**ADDENDUM NUMBER: #2**

Project Name: Tropical Texas Behavioral Health  
HOP Villa Renovations

Milnet Project No.: 217027

Date: September 7, 2018  
Bid Date: September 12, 2018  
Architect: Milnet Architectural Services  
608 S. 12<sup>th</sup> St.  
McAllen, TX 78501

# DAS1.0

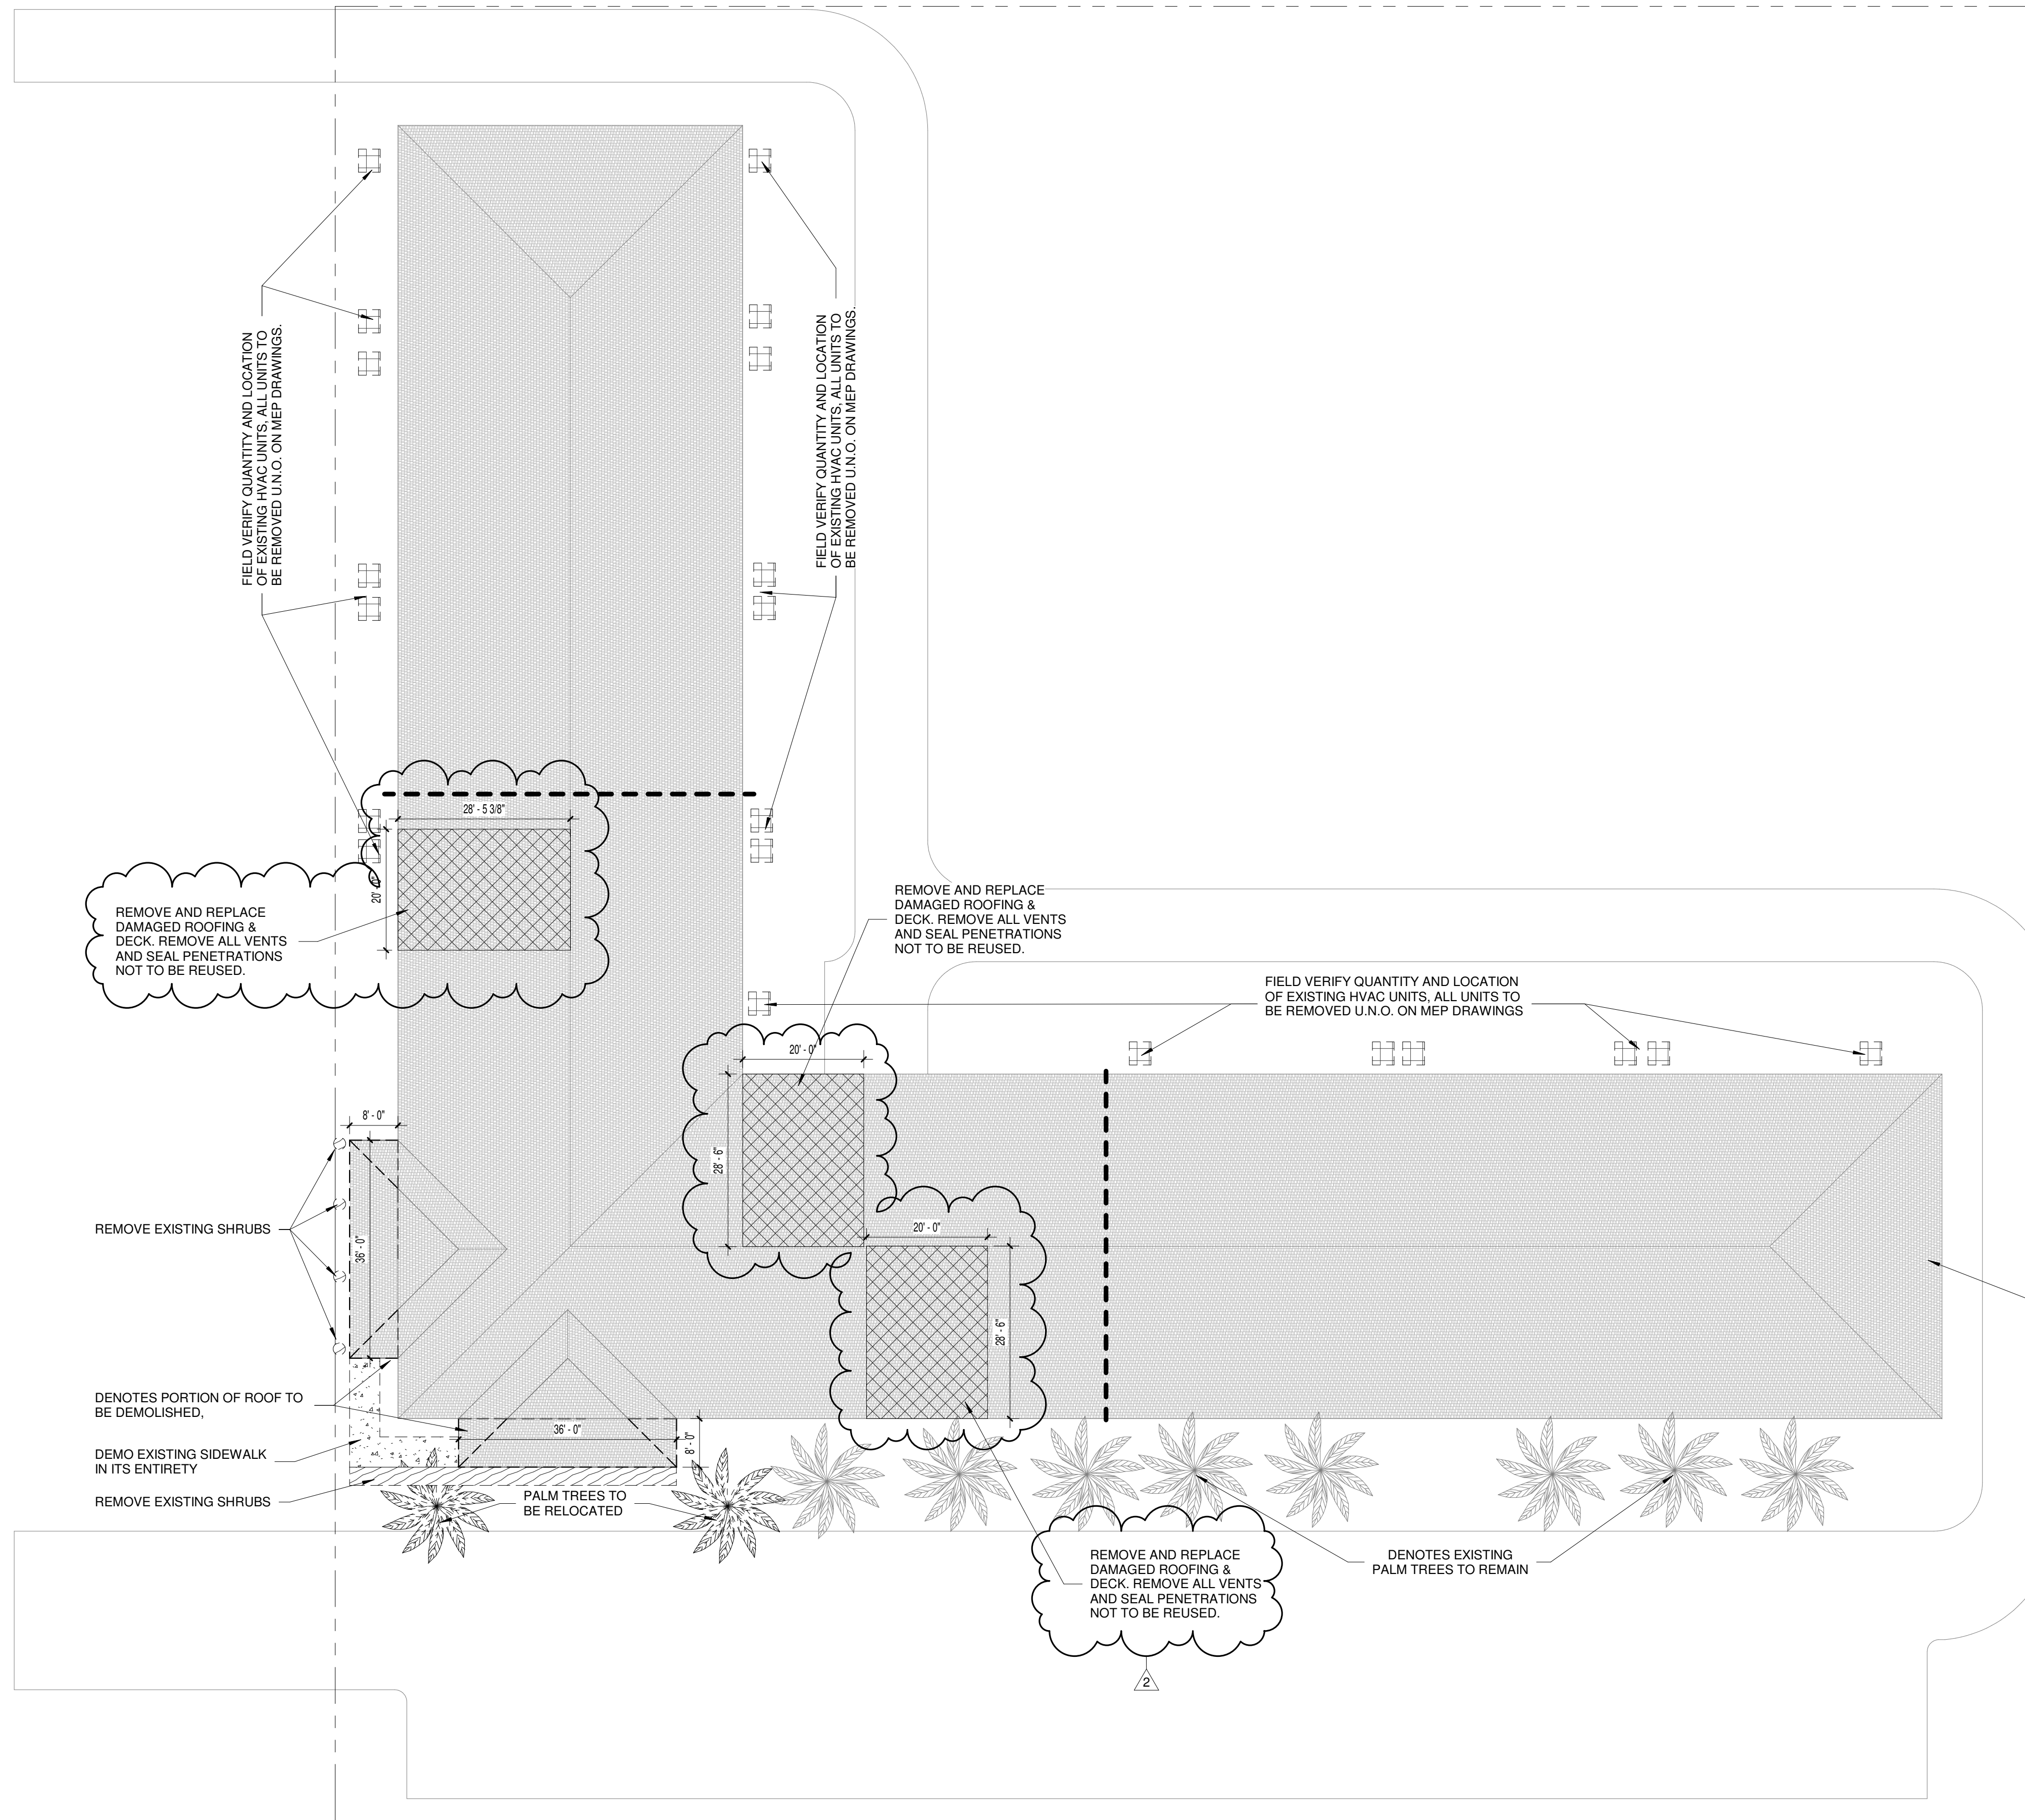
- 2.17 GC Question: "See attached pictures of roof. Some areas of roof it appears that plywood may be deteriorated. You should consider an allowance for roof repairs"?

**Response: Repair of damaged roof is to be included in base bid see attached DAS1.0, roof is to be replaced in its entirety including damaged deck areas as an Alt #1.**

ADD2-AES1.2-a

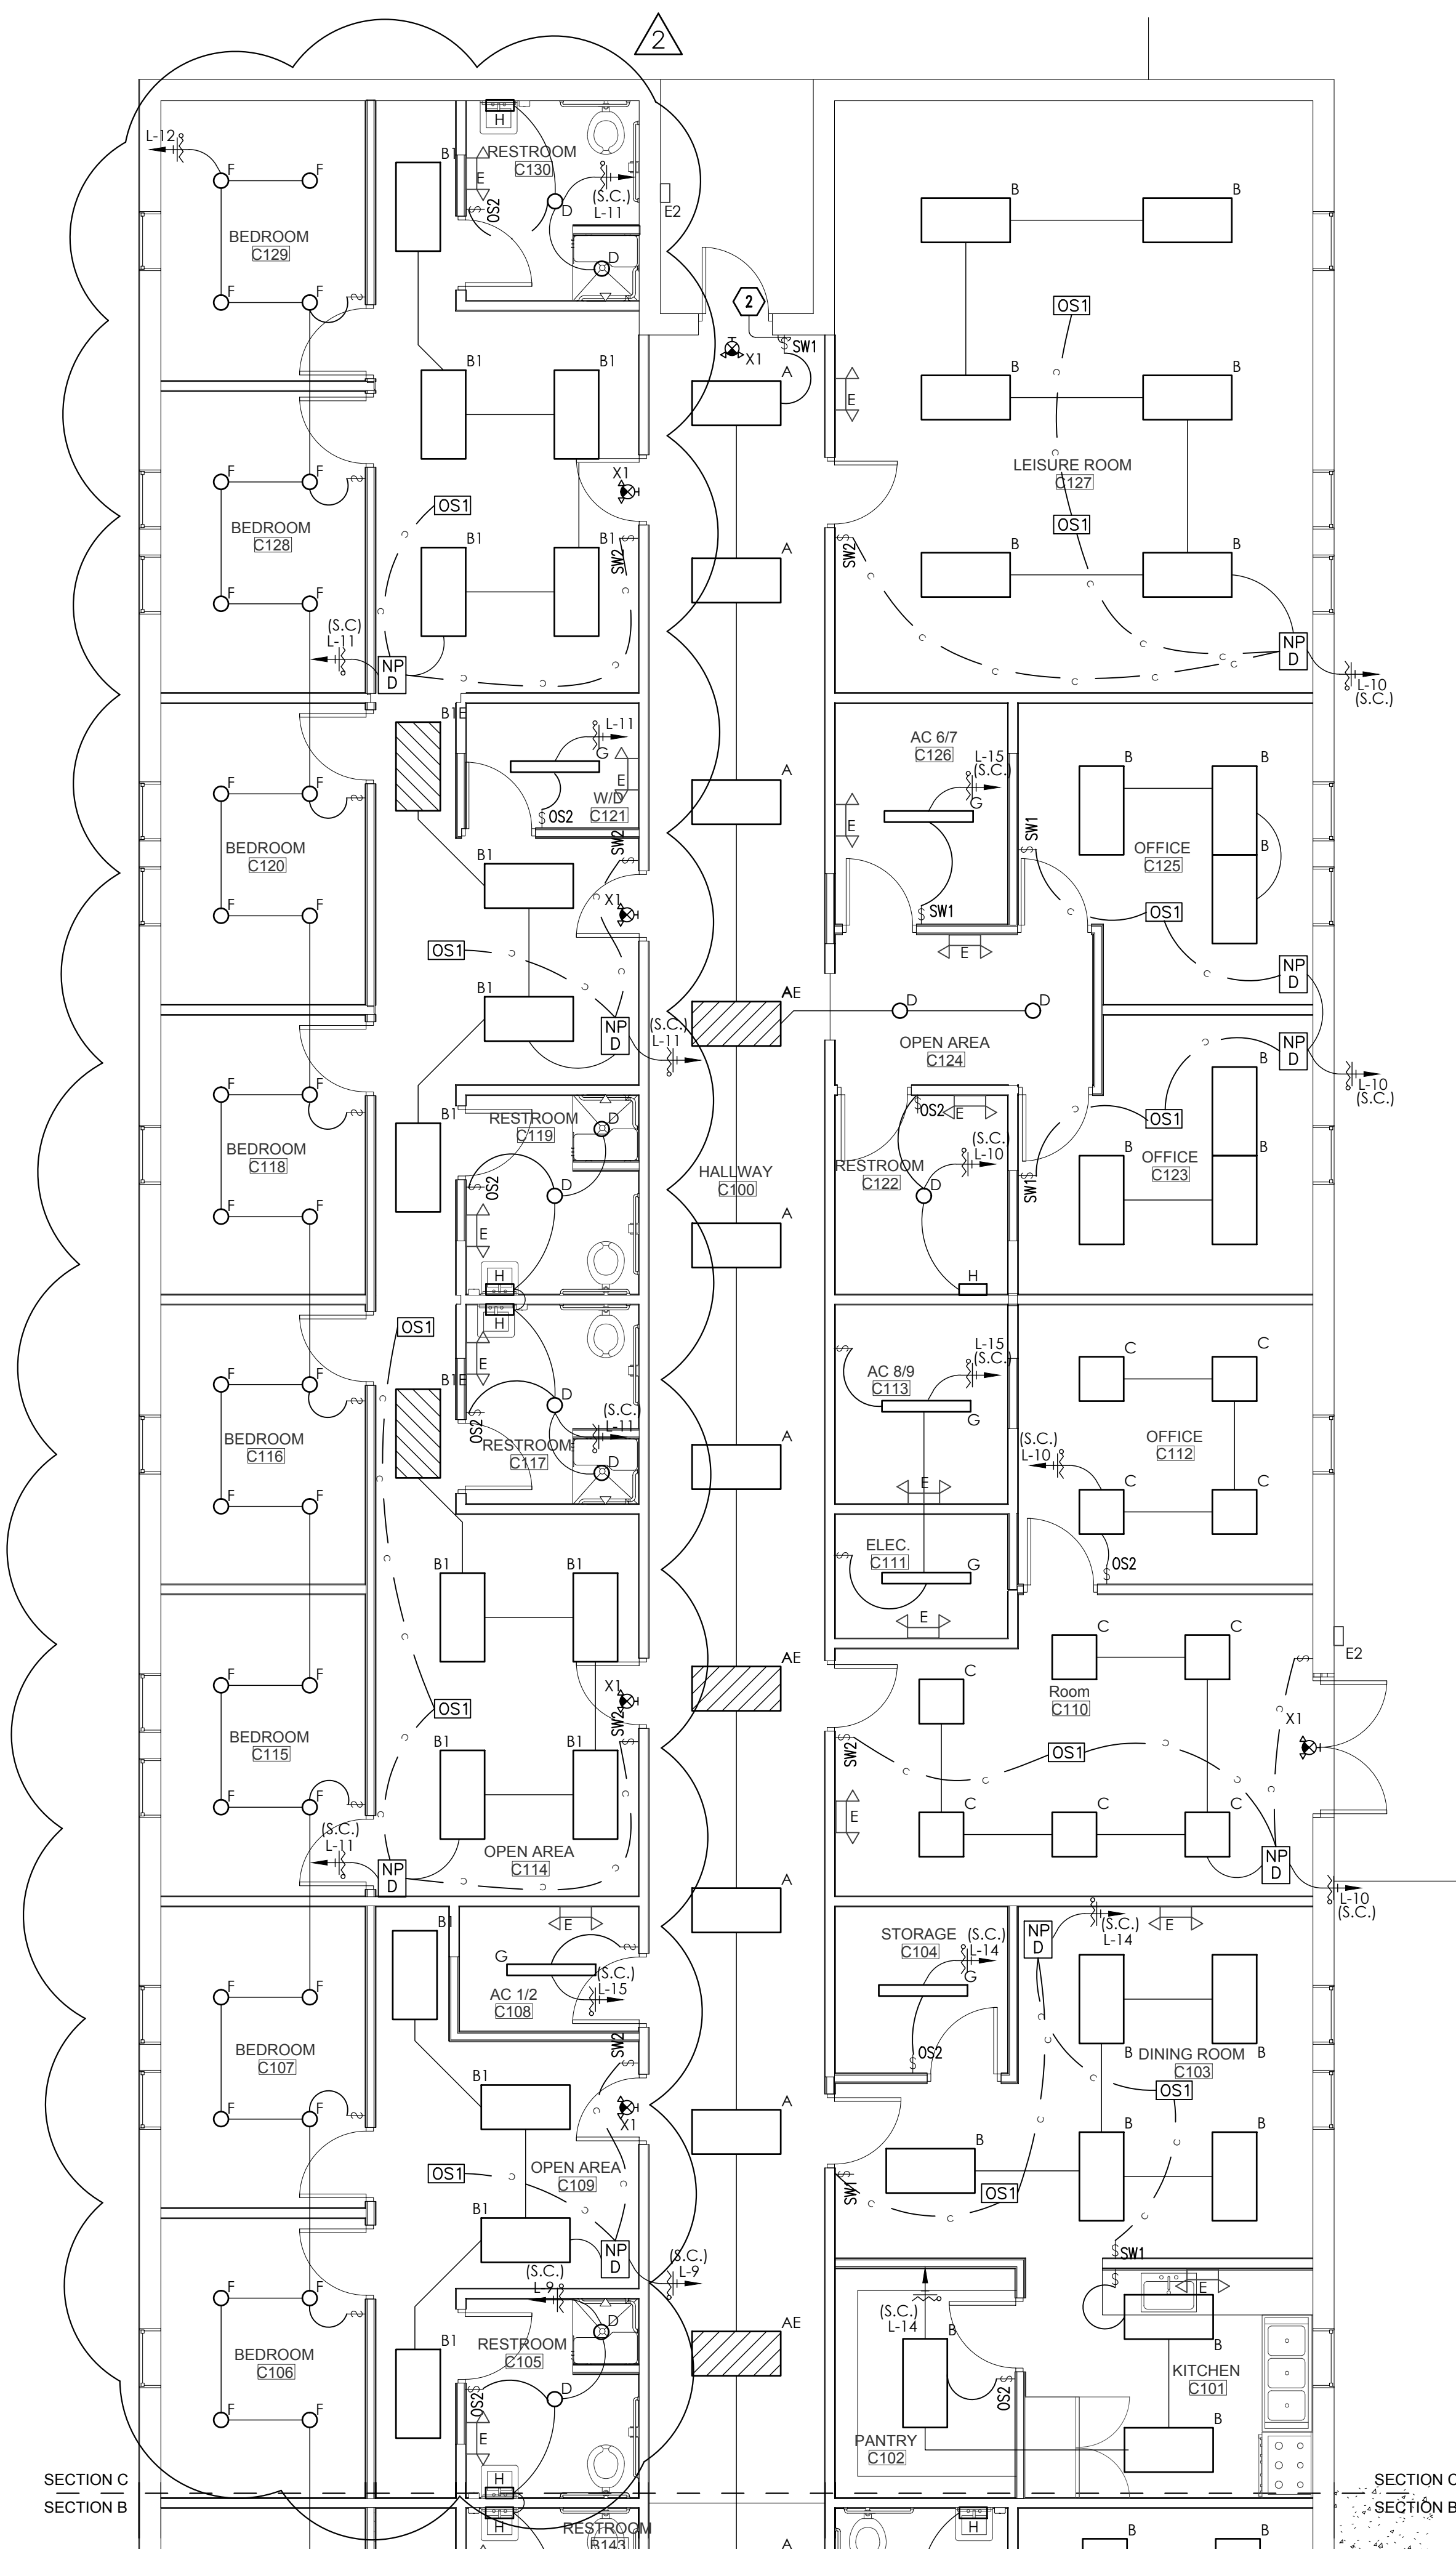
- A. Sheet AES1.2-a – Revise lighting, refer to attached.
- B. Sheet AES1.2-b – Revise lighting, refer to attached.

△<sub>2</sub> ADD2- AE2.2

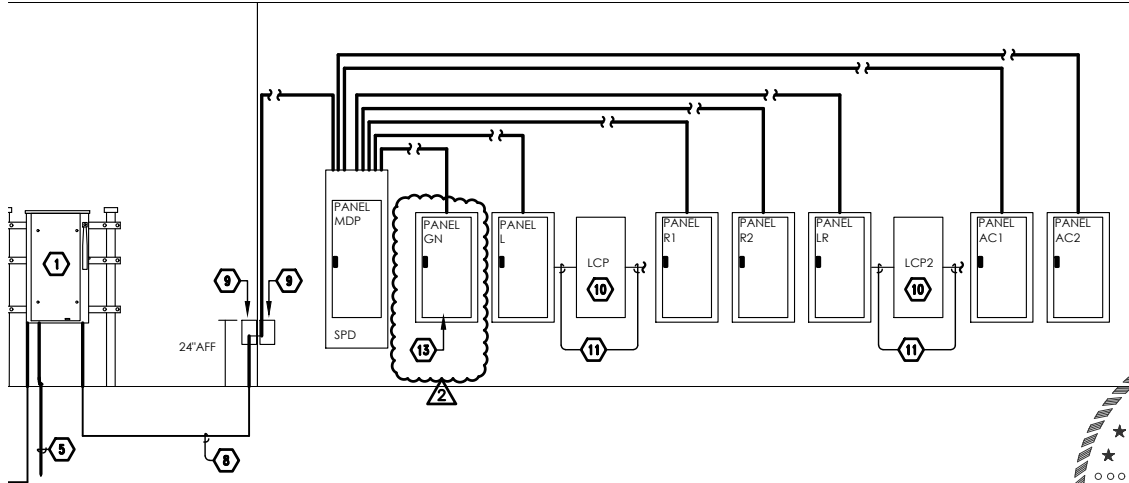
- C. Sheet AE1.3 – Revise lighting, refer to attached.
- D. Sheet AE2.2 – Revise detail #2, refer to attached.
- E. Sheet A4.1 – Revise luminaire schedule, refer to attached.
- F. Sheet AE5.1 – Revise disconnect schedule and electrical schematic diagram, refer to attached.
- G. Sheet AE6.1 – Revise panel MDP schedule, refer to attached.
- H. Sheet E6.1 – Panel R1 sec1 circuits 61,62,63 and 64 shall be spares, each with 20Amp 1-pole breaker.
- I. Sheet E6.1 – Panel R2 sec1 circuits 59,60,61,62,63 and 64 shall be spares, each with 20Amp 1-pole breaker.
- J. Sheet E6.1 – Panel AC2 circuit 10/12 wiring shall be 3#10, 1#10G, ¾" C.
- K. Sheet AE6.2 – Revise panel schedule GN, refer to attached.
- L. Sheet E6.2 – Relay panel LCP and LCP2, note # shall refer to specification 260923.
